ALERT SERVICE BULLETIN

SUBJECT: MAIN ROTOR DRIVE - MGB / engine coupling

Increase of tightening torque of the MGB/engine coupling
Corresponds to modification 079804

Revision No.	Date of issue
Revision 0	2016-06-07
Revision 1	2017-04-25

Figure 1

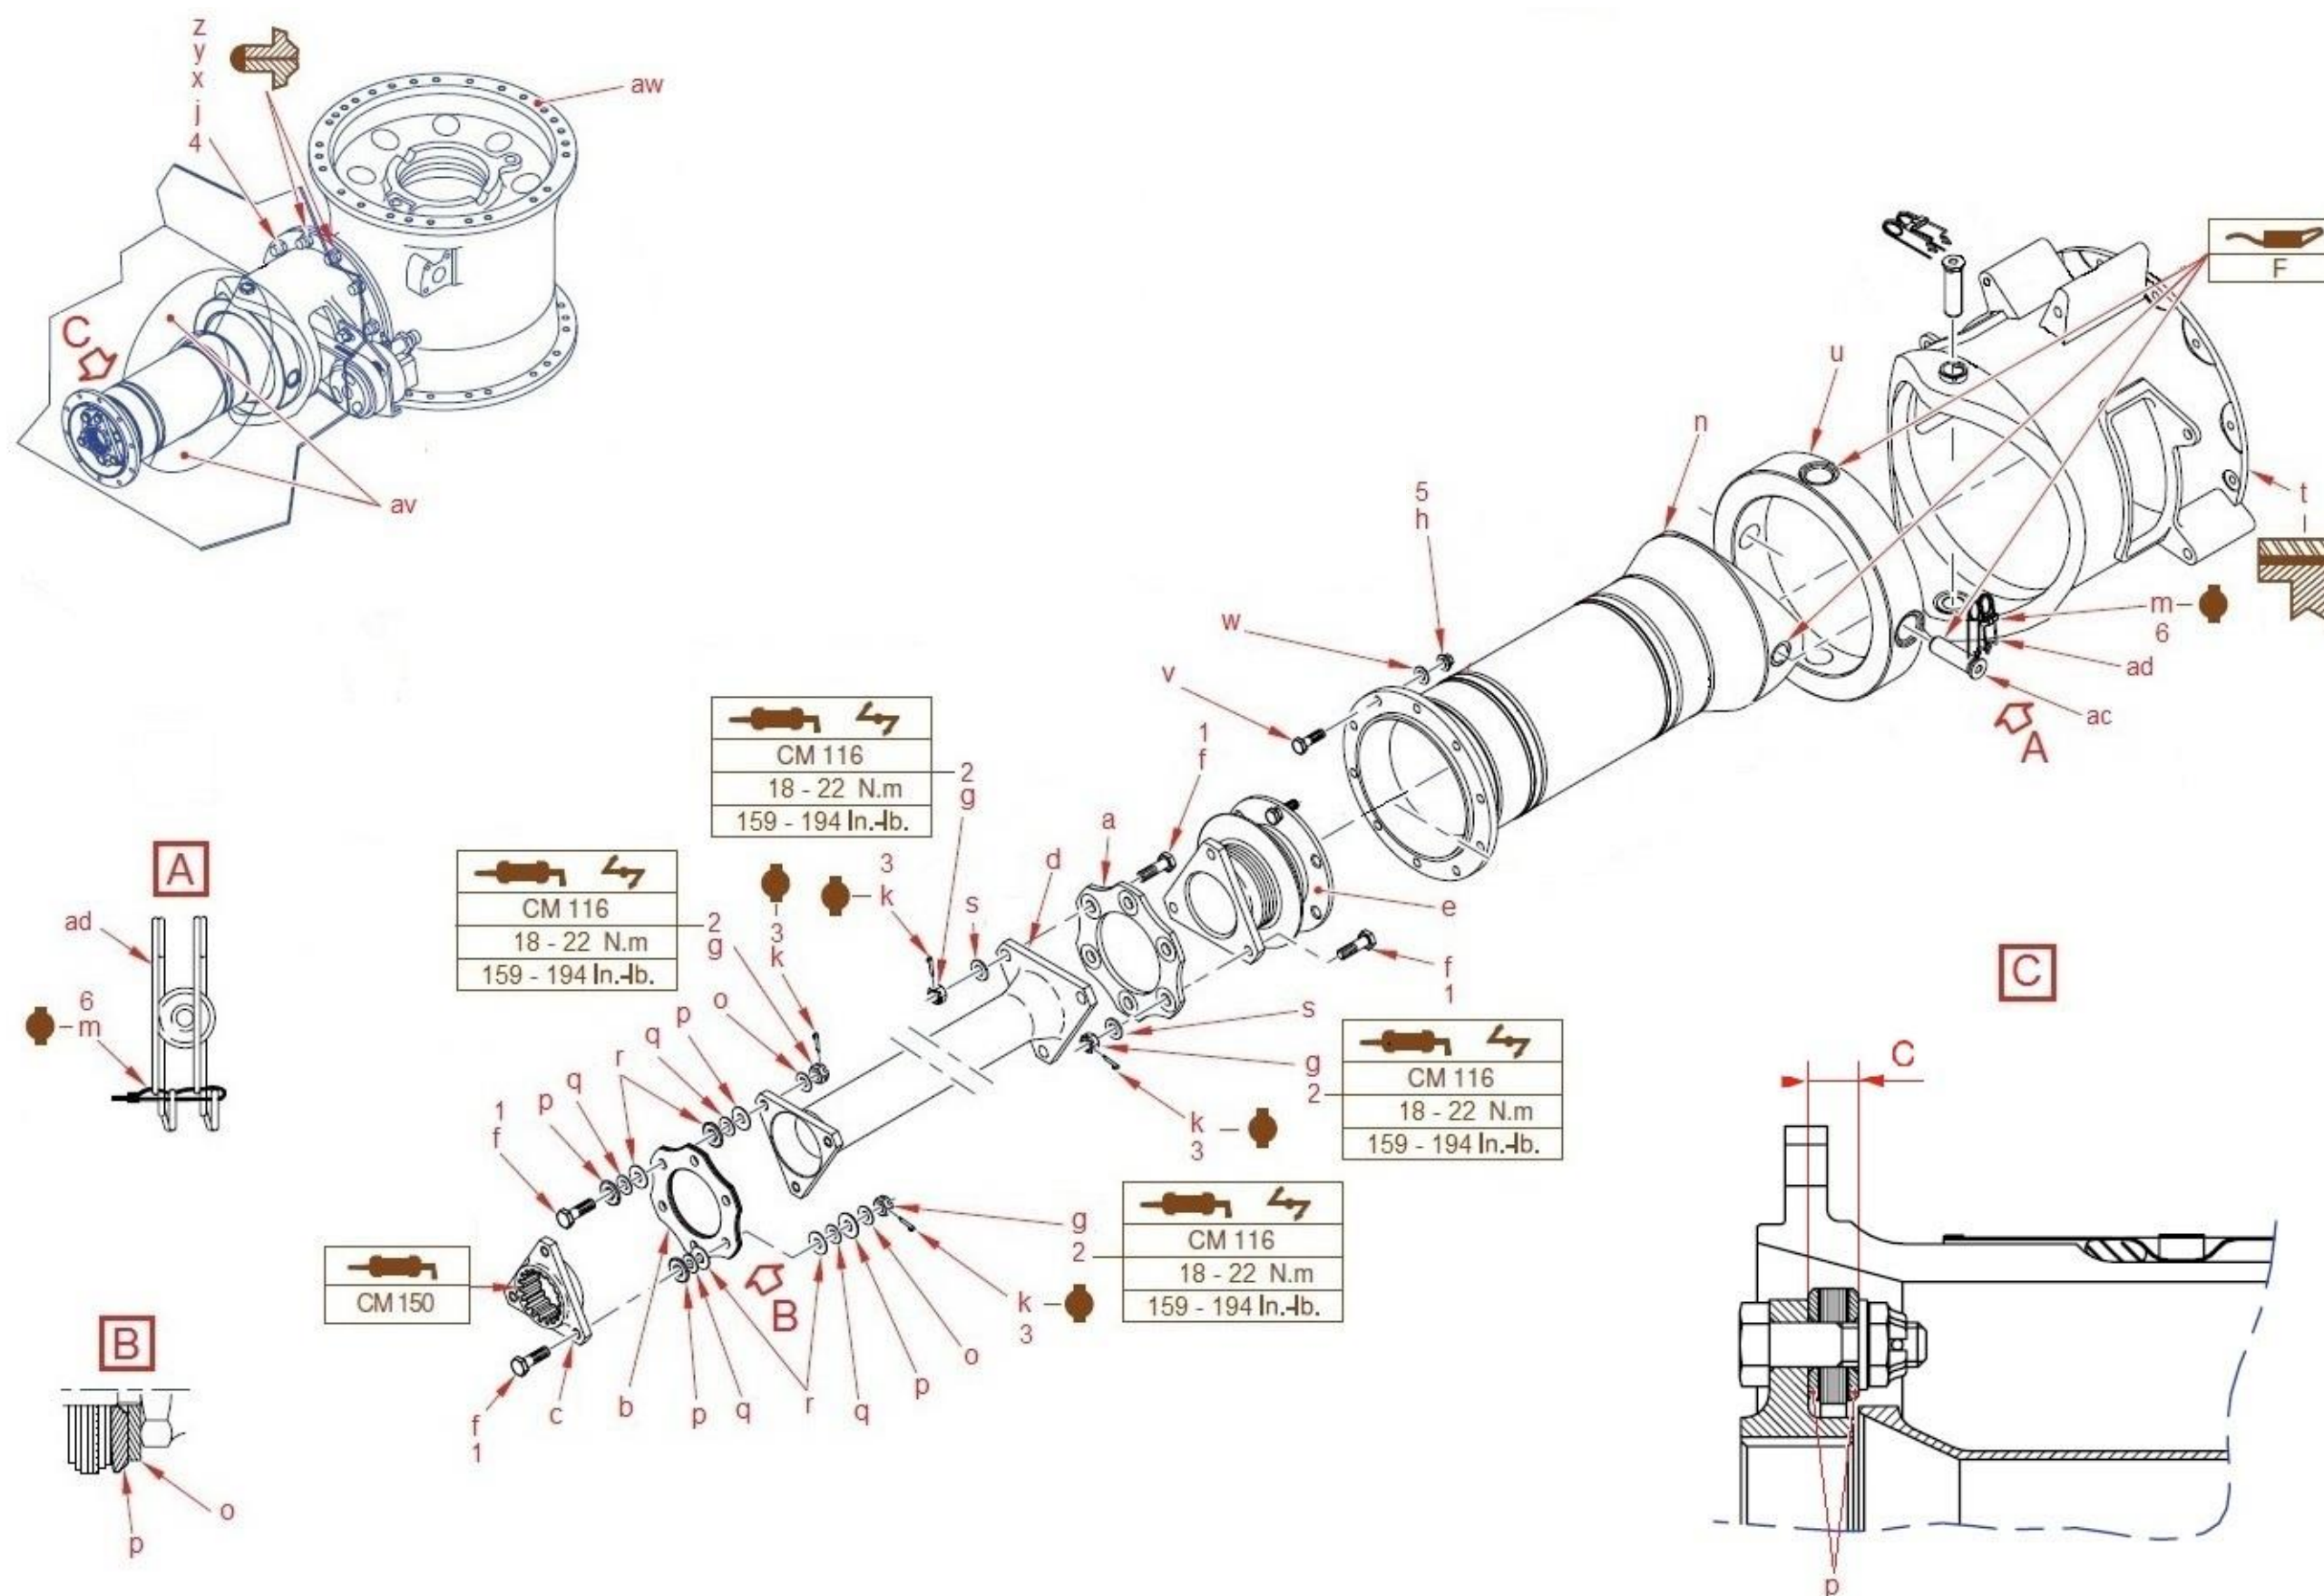
- removing MGB/engine coupling.
- replacing lower castellated nuts with higher elliptic castellated nuts in order to increase the number of engaged threads,
- replacing the screws with longer screws for compatibility with elliptic castellated nuts,
- increasing the tightening torque of flexible coupling attachment screws,
- modifying the identification of the engine flange assembly,
- modifying the identification of the MGB/engine coupling assembly.

**SCREWS (f) HEAD (PRE MOD 079804) IS PAINTED.
IN ORDER TO VISUALLY AND CLEARLY INDICATE
COMPLIANCE WITH MODIFICATION 079804,
SCREWS (1) HEAD (POST MOD 079804) IS NOT
PAINTED.**

- Remove and scrap one of the three screws (f) as well as its nut (g) and its pin (k).

*Mark the order of washers (o), (p), (q) and (r) located on
either side of flexible coupling (b) (DETAIL B).*

- Install one screw (1), washers (o), (p), (q), (r) and one nut (2) by respecting the order of the washers previously recorded.
- Repeat the operation for the other two attachment screws.
- Tighten nuts (2) to indicated torque.
- Make sure that dimension "C" between the two rounded washers (p) is 9 mm ± 0,2 mm (.347 in.; .362 in.) (DETAIL C).
- Remove if necessary, the assembly to add or remove one or several flexible coupling disk(s) to obtain dimension "C" and tighten again nuts (2) to indicated torque.
- Lock the three nuts (2) with pins (3).
- Modify the identification of the MGB/engine coupling assembly (on MGB junction casing (t)) and engine flange (c) as per [paragraph 3.C.](#)

- Remove and scrap one of the three screws (f) as well as its nut (g) and its pin (k).
- Install one screw (1), washer (s), and one nut (2).
- Repeat the operation for the other two attachment screws.
- Tighten nuts (2) to indicated torque.
- Lock the three nuts (2) with pins (3).

After compliance with this ALERT SERVICE BULLETIN, and pending this update, use the tightening torque indicated on Figure 1 on the nuts attaching the flexible couplings.

Figure 2

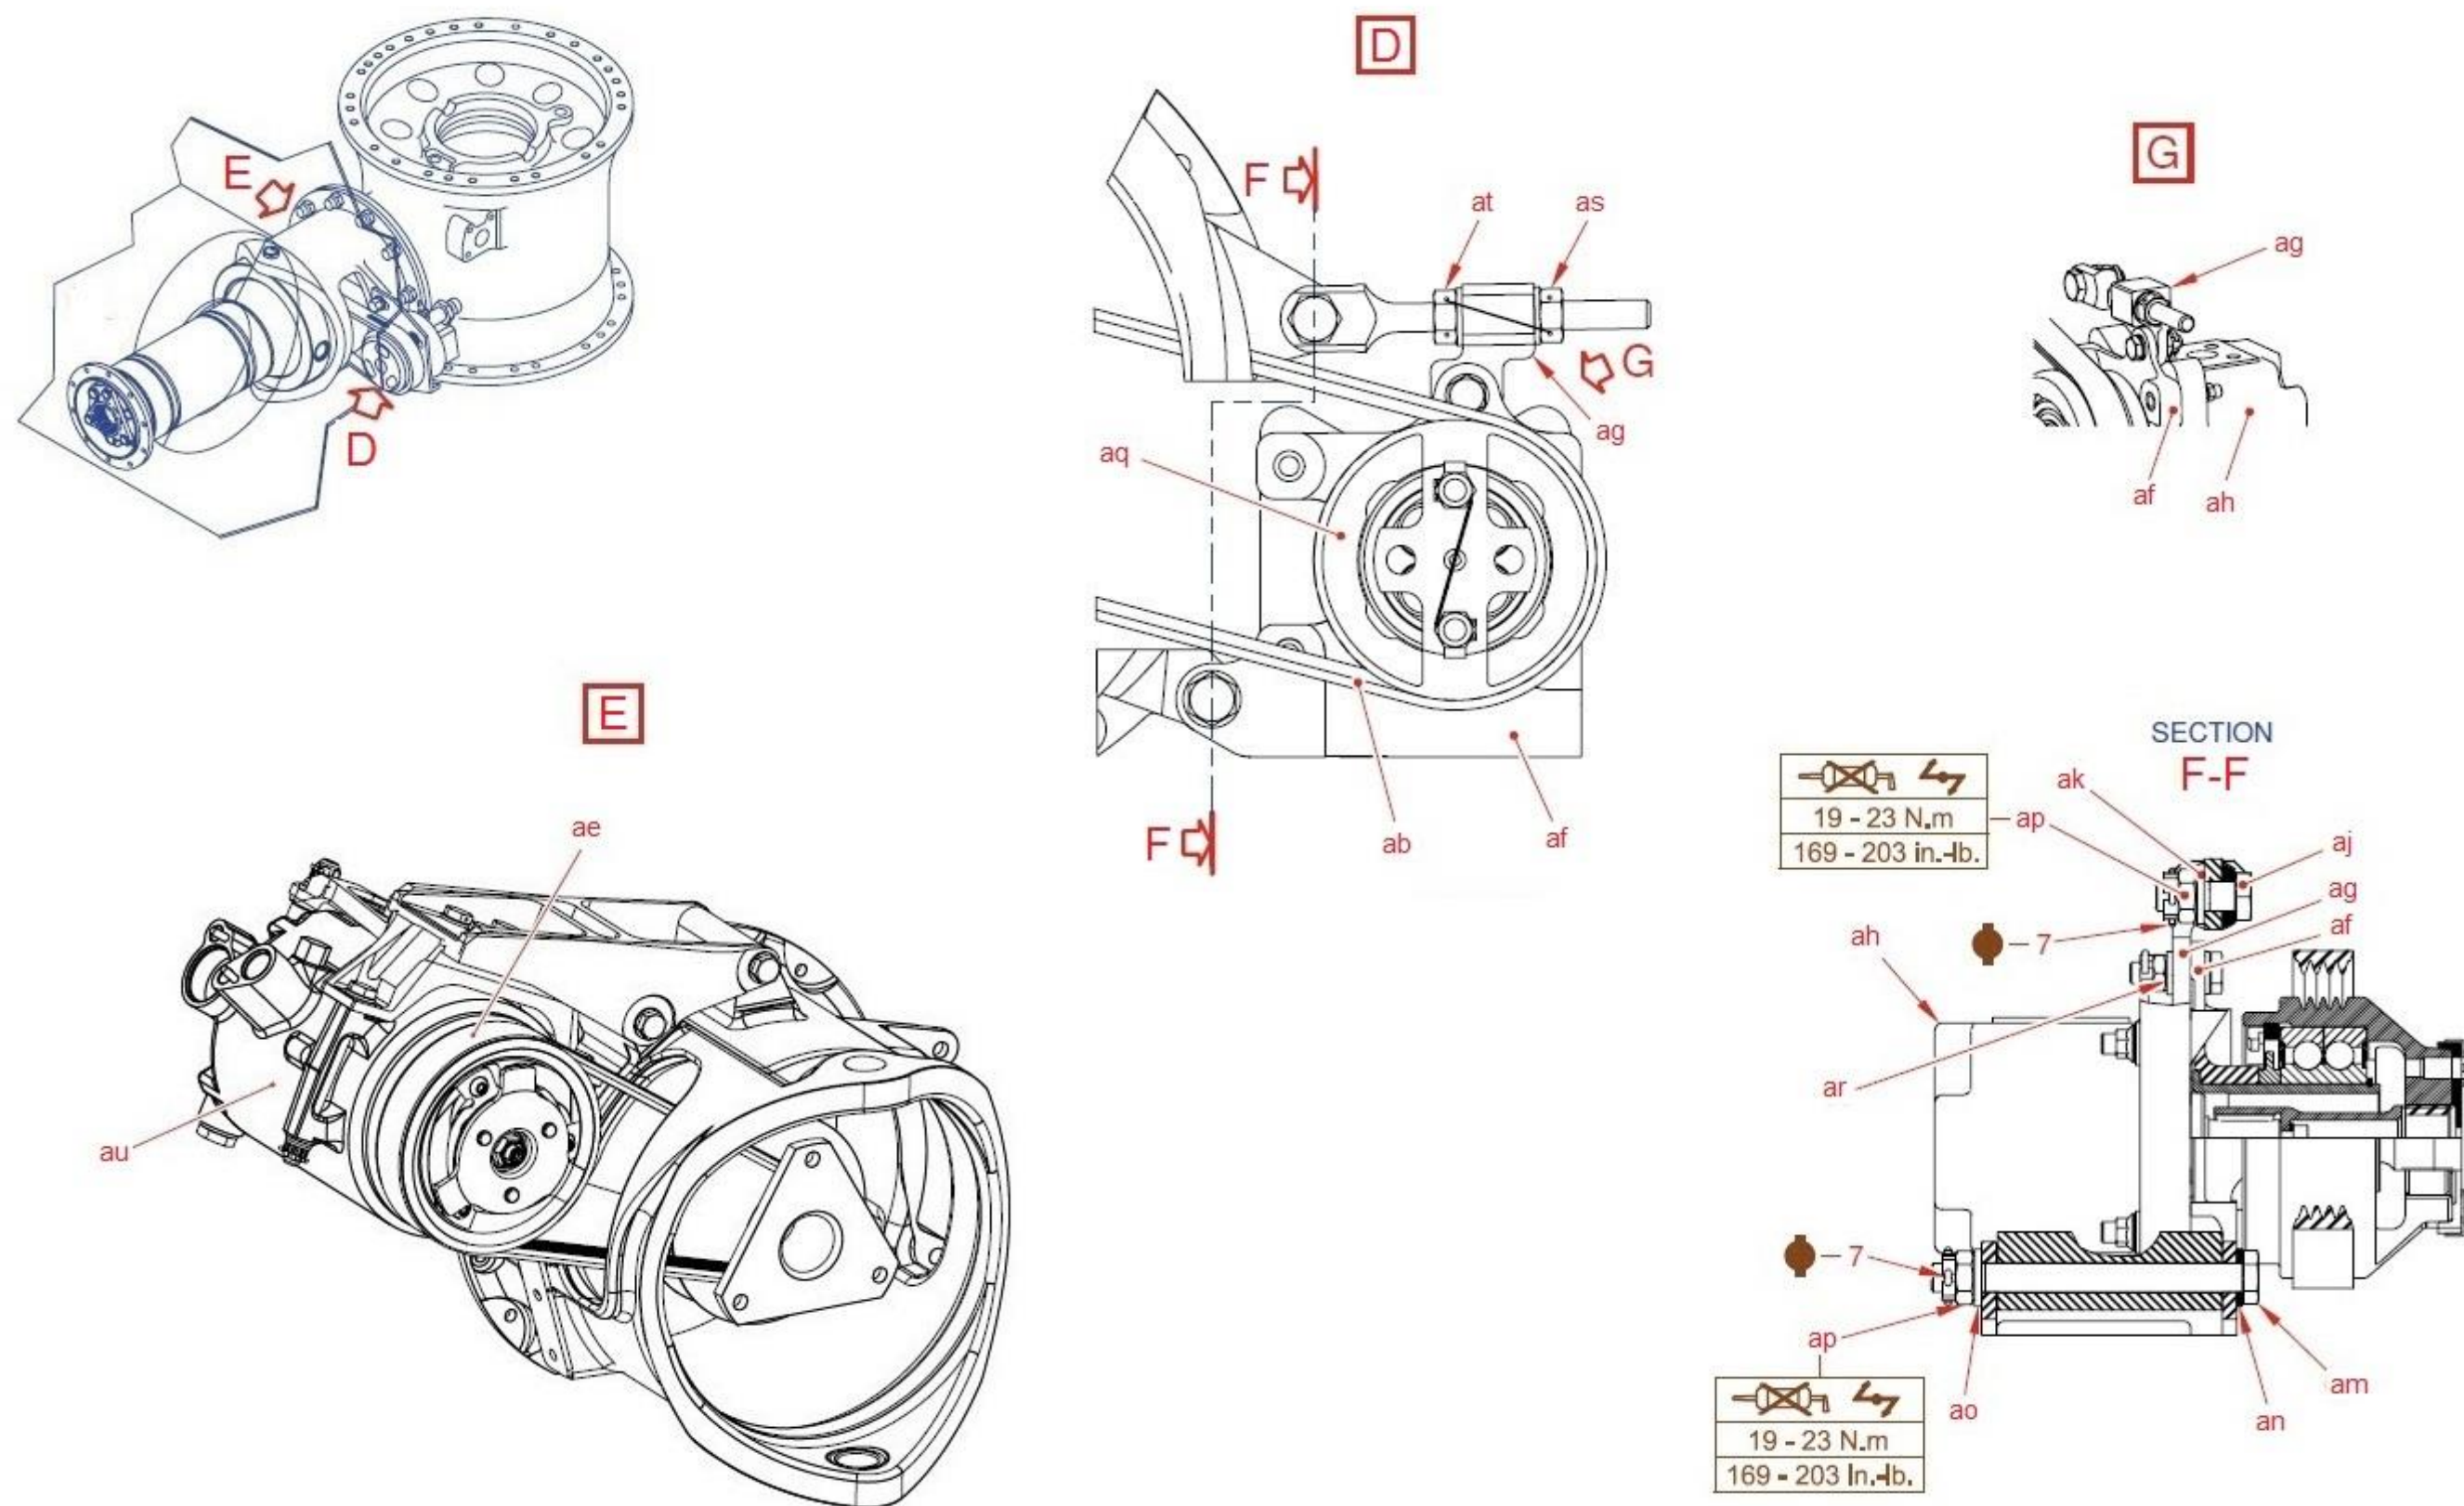
- . Tighten nuts (2) to indicated torque.
 - . Lock the three nuts (2) with pins (3).
- Make MGB junction casing (t) slide frontwards, complete with gimbal ring (u) and introduce hydraulic pump drive belt (ab) and, if necessary, optional drive belt (ae) in the windows of MGB connection casing (t) ([Figure 2](#)).

- Install hydraulic pump drive support (af) (DETAIL D - [Figure 2](#)):

MAKE SURE THAT TENSIONER YOKE (ag) IS POSITIONED ON SUPPORT (af) FACE ON HYDRAULIC PUMP ASSEMBLY (ah) SIDE (DETAIL G).
